PERMIT

SEWAGE DISPOSAL SYSTEM

DEPARTMENT OF HEALTH AND MENTAL HYGIENE

SUBDIVISION Thistledown LOT 10 ROAD 7209 Tall Pine Way

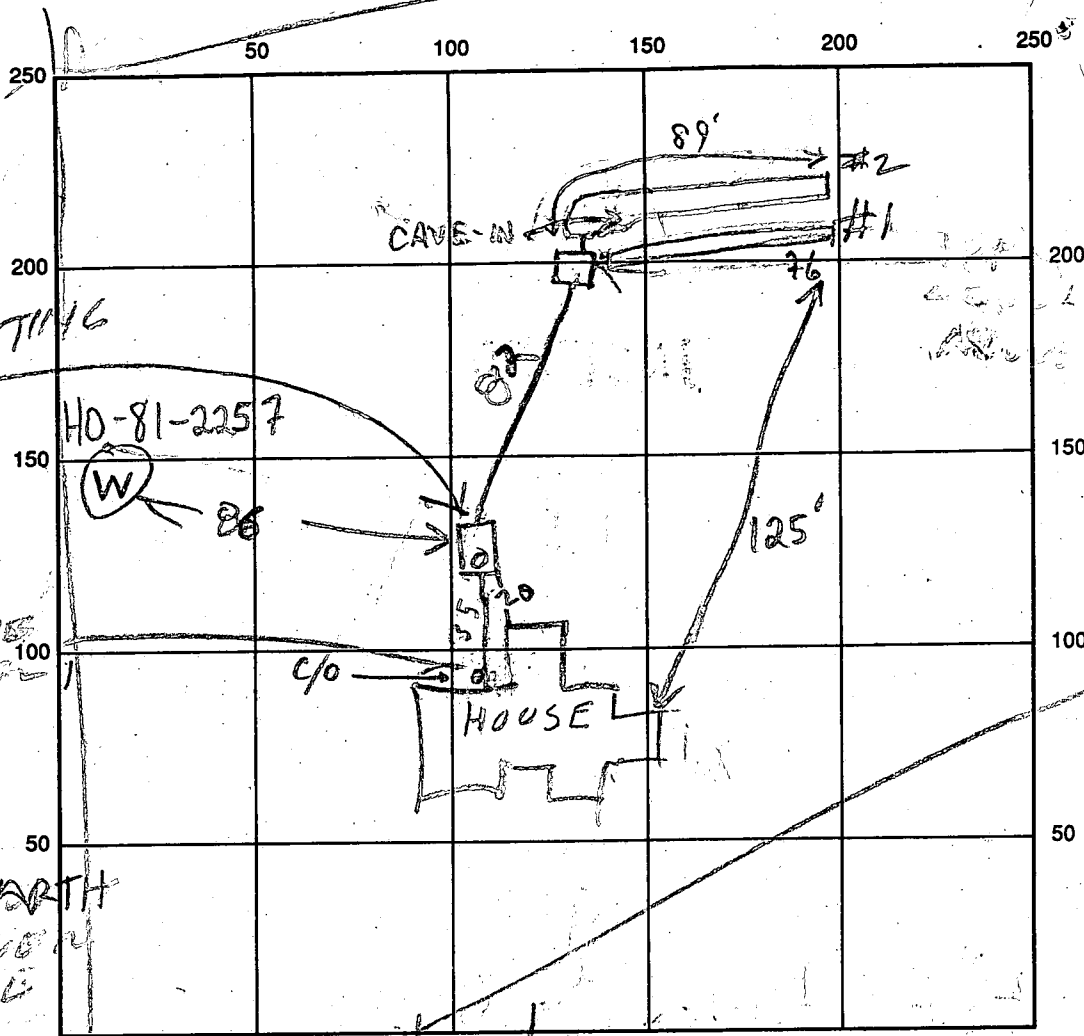
TANK FLOATING
10/9/92 RH

REMARKS 10/8/92 - HOLD FOR REVIEW - TANK TOO CLOSE
TO WELL & TOP OF TANK ABOVE GRADE 10/9/92 NO ONE PRESENT MR
10/9/92 - TANK FLOATED. RESET TANK OK TO HAVE TANK
86 FT FROM WELL OK TO HAVE HOUSESEWER GRADE LEVEL BUT
MUST BE COVERED LATER WITH 12" EARTH & CHECKED AFTER COVERING
TRENCH #1 NOB. ADD STONE. CONTINUE WORK & CALL 10/13/92 RH

10/14/92 #1 FINISH TRENCHES (AT IN ELEV OFF CONTOUR) & RE-SET TANK MR
10/14/92 #2 TRENCHES OK, TANK NOT SET, D.B. COULD NOT RIGHT MR
